## **Proposal for the 04 Series of Amendments to UN Regulation No. 129 (Enhanced Child Restraint Systems) \***

### **Submitted by the expert from the Netherlands**

The text reproduced below was prepared by the Ad Hoc Group on CRS, aiming to introduce definitions, requirements and a test procedure for lower tether anchorages. The modifications to the existing text of the UN Regulation by document ECE/TRANS/WP.29/GRSP/2023/13 are marked in “bold black“ for new or strikethrough for deleted characters. The modifications made by this document are marked in “**(bold) blue**” for new or strikethrough for deleted characters.

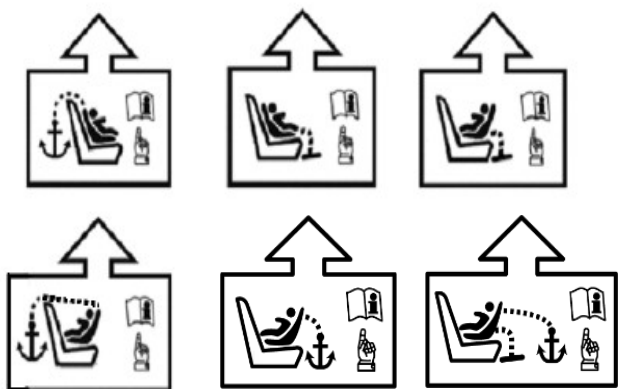
- (c) The position and if necessary, the routing of top tethers, **lower tethers**, or other means of limiting Enhanced Child Restraint System

rotation requiring action by the user, shall be indicated using one or **more** of the following symbols as appropriate:

Figure 3 (f)  
Generic Lower Tether Bracket

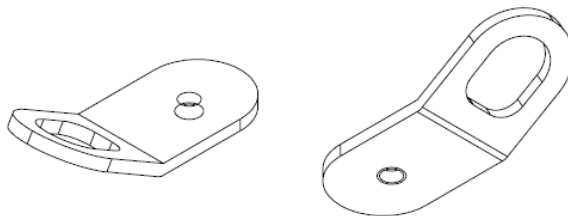
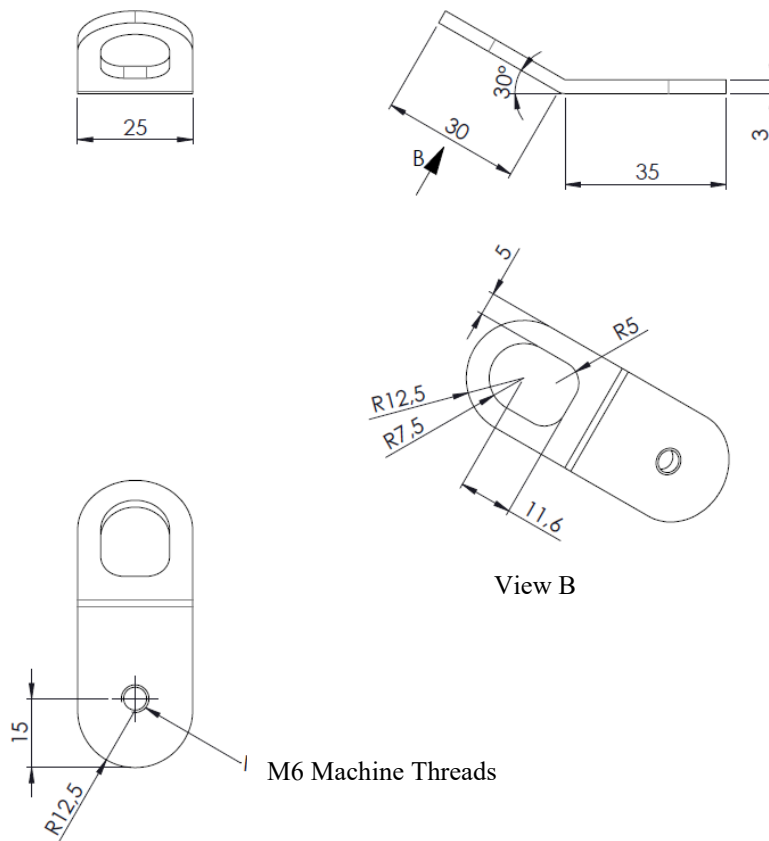
- 6.3.7.2. Dimensions bracket:**
- (a) The generic lower tether bracket shall have dimensions according to Figure 3 (f);
  - (b) The outer edges of the lower tether bracket shall be at least blunted.

Figure 3 (g)  
M6x8 Flange Buttonhead Hexagon Socketcap Screw (ISO 7380-2)

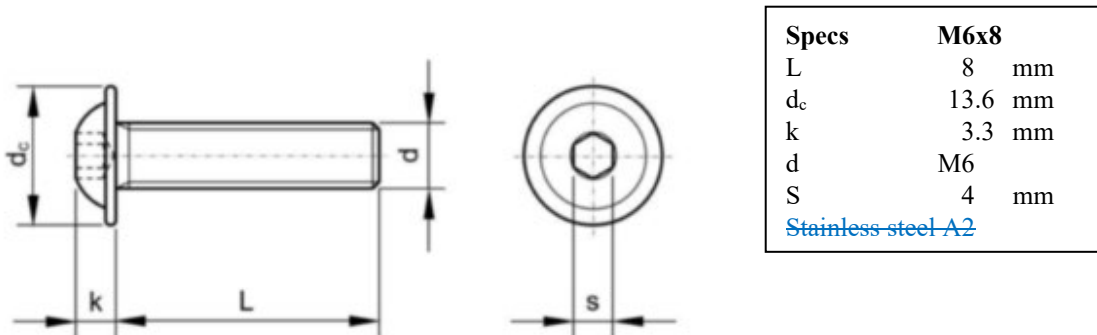
- (a) M6x8 flange buttonhead hexagon socket-cap screw see figure 3 (g);
- (b) M6 washer; see figure 3 (h);
- (c) M6 -8 shoulder washer; see figure 3 (i).

Figure 3 (j)

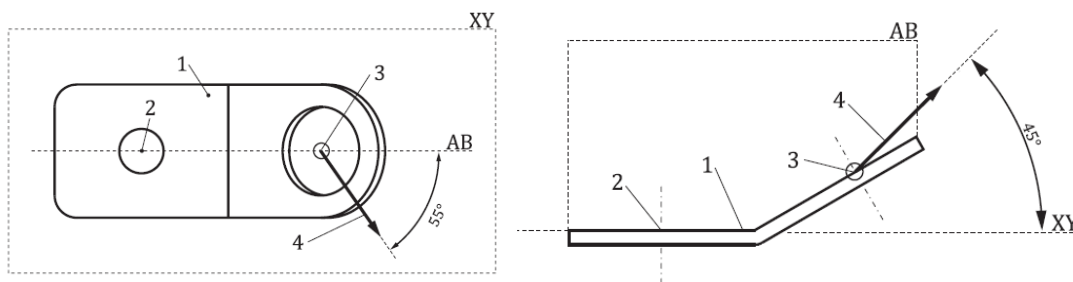
(a) the force shall be applied in a direction of  $55^\circ \pm 5^\circ$  against plane AB, measured in a plane parallel to the rigid surface XY, and a direction of  $45^\circ \pm 5^\circ$  against the rigid surface XY, measured in plane AB; **rotation around the anchorage point to vehicle (2) shall be prevented.** see figure 3 (j);

- Key:**
1. generic lower tether bracket (not actual design).
  2. anchorage point to vehicle.
  3. anchorage point lower tether hook.
  4. test 1 - force direction.
  5. the XY plane is located on top of the bracket (thus loading the thread inside the bracket)

## Figure 3 (k)

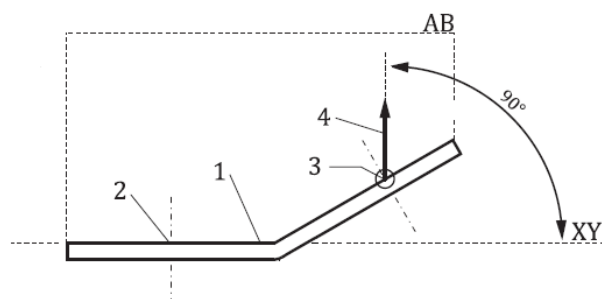
(b) the force shall be applied in a direction perpendicular ( $90 \pm 5^\circ$ ) to the rigid surface XY.

- Key:**
1. generic lower tether bracket (not actual design).
  2. anchorage point to vehicle.
  3. anchorage point lower tether hook.
  4. test 2 – force direction.
  5. the XY plane is located on top of the bracket (thus loading the thread inside the bracket)

**Test Arrangement for a Rearward-Facing Device, not supported by the dashboard**

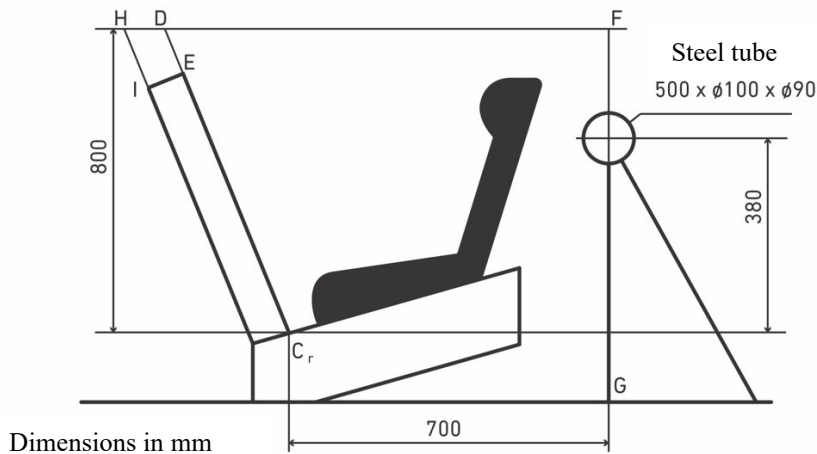
Where a test is conducted with paragraphs 6.6.4.1.6.1.1. or paragraph 6.6.4.1.6.1.2. or paragraph 6.6.4.1.8.2. above, only the second test results without 100 mm diameter bar will be considered. **A tolerance of +10 per cent shall be applied to the head excursion value distance between the Cr point and plane DF, and the dummy should not pass beyond the plane HI, parallel to plane DE.**"

Figure 5, amend to read:

**Top View – Bench with Lower strap-Tether Anchorages**  
(LTA 1, LTA 2, LTA 3 and LTA 4)

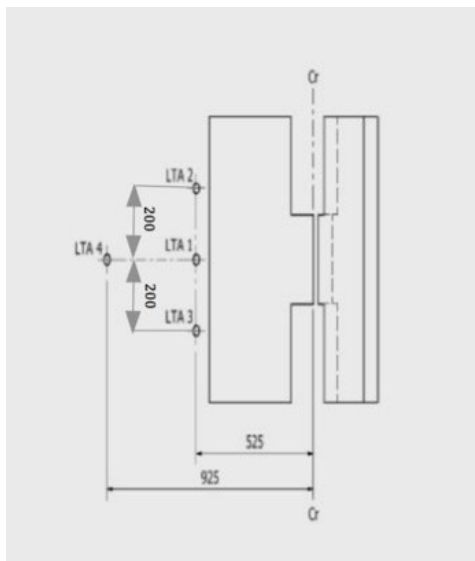
5. **For the testing of Enhanced Child Restraint Systems with lower tether(s), the floor shall be placed in its lowest position. LTA 4 is to be used in case the top tether anchorage from the seat in front is used. Otherwise LTA 2 and LTA 3; see figure 5. Generic lower tether brackets to be used for the dynamic test in case they are provided by the CRS manufacturer.**

Annex 6, Appendix 2, figure 5, amend to read:
